SUBJECT: REACTOR SYSTEMS BRANCH SAFETY EVALUATION INPUT
TO BYRON STATION UNITS 1 AND 2 AND BRAIDWOOD
STATION UNITS 1 AND 2 MEASUREMENT UNCERTAINTY
RECAPTURE POWER UPATE

By letter dated June 23, 2011, Exelon Generation, the licensee for Braidwood Station Units 1 and 2 and Byron Station Units 1 and 2, submitted a License Amendment Request (LAR) to revise the Operating License and Technical Specifications (TSs) as necessary to increase the licensed core power level by approximately 1.63% from the Current Licensed Thermal Power (CLTP) of 3586.6 MWt to 3645 MWt.

REACTOR SYSTEMS BRANCH
SAFETY EVALUATION INPUT TO BYRON STATION UNITS 1 AND 2
AND BRAIDWOOD STATION UNITS 1 AND 2 MEASUREMENT
UNCERTAINTY RECAPTURE POWER UPATE

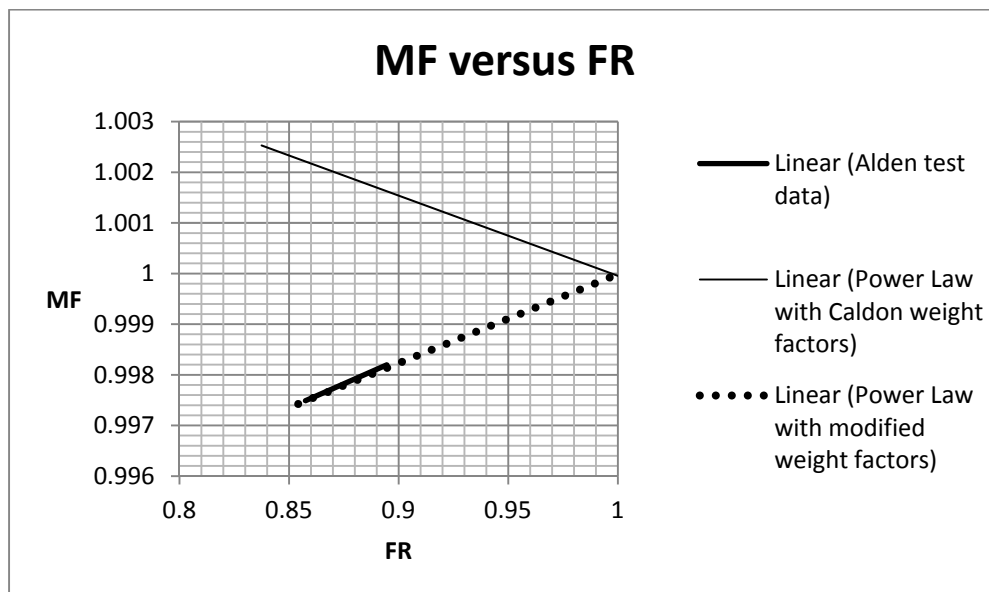
Each of the four CheckPlus LEFMs installed at Byron 1 was tested at Alden Labs. There were three test piping configurations in addition to a configuration to model the plant installation for each CheckPlus. More than one flow rate was included in each configuration test. The configuration variations were, for example, to introduce swirl to bracket any variations that would be encountered in the plant. The test report (Spadaro, July, 2010) provided FR versus MF for each of the 16 test configurations. All MF's were less than one yet, as stated above, the results were plotted on Estrada's straight line where the line is limited to $MF > 1$. This was achieved by offsetting the MF for each meter such that the average MF was on the predicted curve. The offset "data" correspondence to the straight line was an excellent fit. Caldon explained that the purpose of this work was to illustrate the dependence of MF on FR and, in this case, the change was small, as is discussed below.

The NRC staff calculated MF behavior using the power law and the Caldon weighting factors and compared it to a straight line fit of the Alden Labs test results for the four LEFMs installed at Byron 1. The comparison is shown in the following figure where the upper solid line is the calculation and the lower solid line is a straight line fit to the data. There is effectively no correspondence. The NRC staff also modified the weighting factors so that the power law reproduced the mean MF and FR of the 16 Alden Lab test results and, using the modified weighting factors, repeated the calculation to obtain the dash line. The fit of the power law to the data line is excellent.

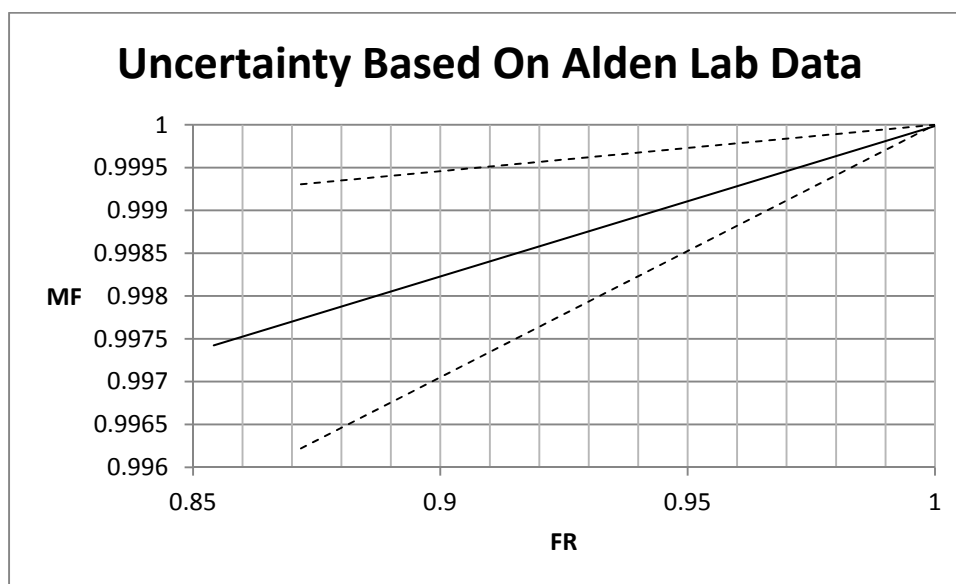
The above calculations were based on nominal test values without considering the Alden flow rate uncertainty. There is significant scatter in the 16 data points, in part due to testing different configurations to bracket possible variations introduced in the plant installation. Simply obtaining the standard deviation, σ , without considering variation in FR, approximating uncertainty as two times σ , and applying the uncertainty at the mean FR of the data provided the following approximation of the data scatter. Note that the upper extreme never reaches

MF = 1 except at FR = 1 in contrast to the Caldon extrapolation of the data to the Caldon calculation that Caldon used to evaluate MF sensitivity. Further note that Caldon's approach results in a reduction in MF with increasing FR whereas the Alden data establishes that MF increases with increasing FR. In contrast, the absolute magnitude of the MF changes is identical due to the mirror image of the two calculations with respect to MF = 1.
